Product Change Notification

Change Notification #: 106144 - 00
Change Title: Intel NetStructure® IXB2850XGBE, IXB28504XGBEFS, PCN 106144-00, Product Design, Design change to prevent resetting of board when switching the redundant power source on and off
Date of Publication: March 31, 2006

Fig.1 Q18 location on baseboard

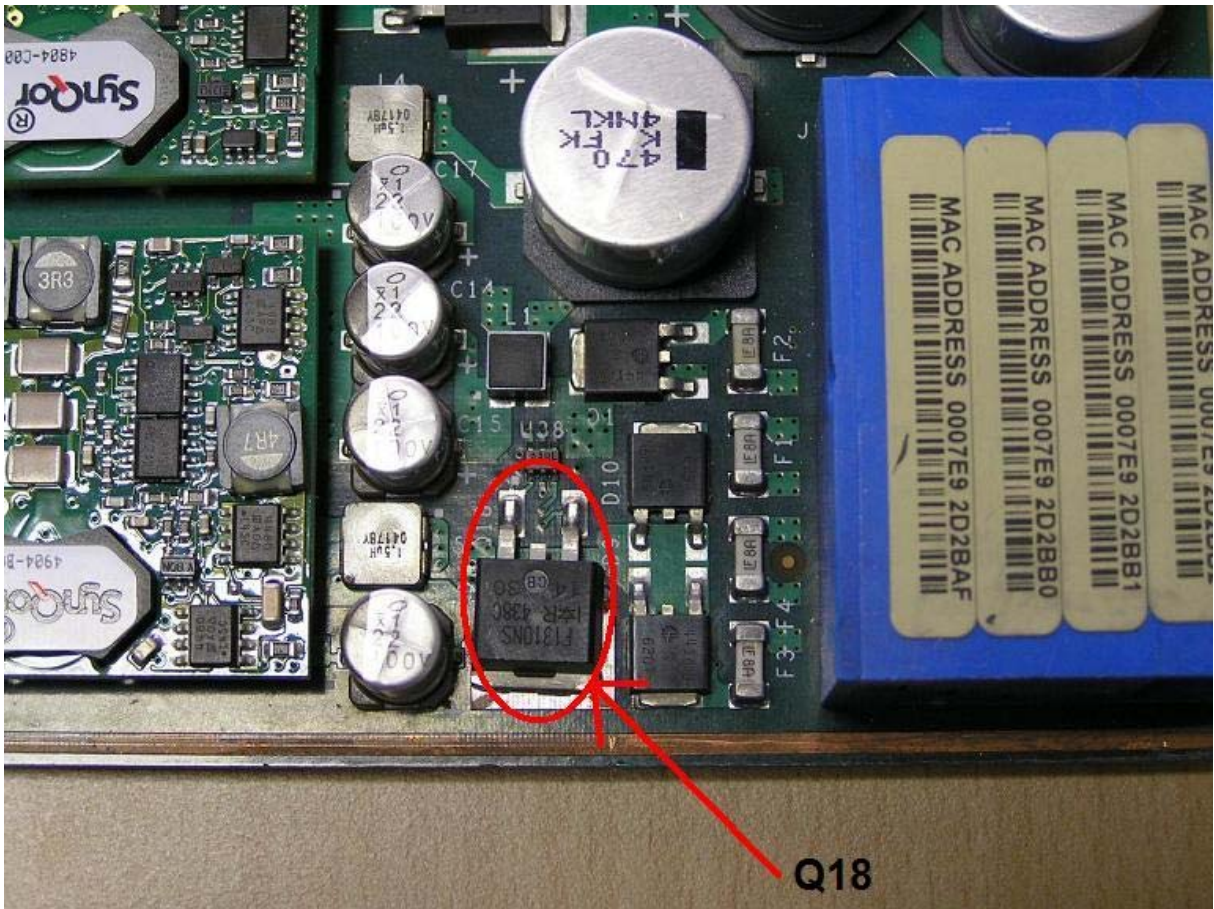
To prevent resetting of the board that is operating when redundant power sources is being switched on and off requires a component change in the input protection circuit. The component to be changed is transistor Q18 located on the baseboard between the blue connector and main DC-DC converters, close to the edge of the board—see Fig.1 below.

Power MOSFET transistor Q18 is replaced with a transistor that has a much lower channel resistance. Since the board reset is initiated by the voltage drop across the channel resistance this change makes the protection circuit less sensitive to transients. This change does not affect ATCA compliance.
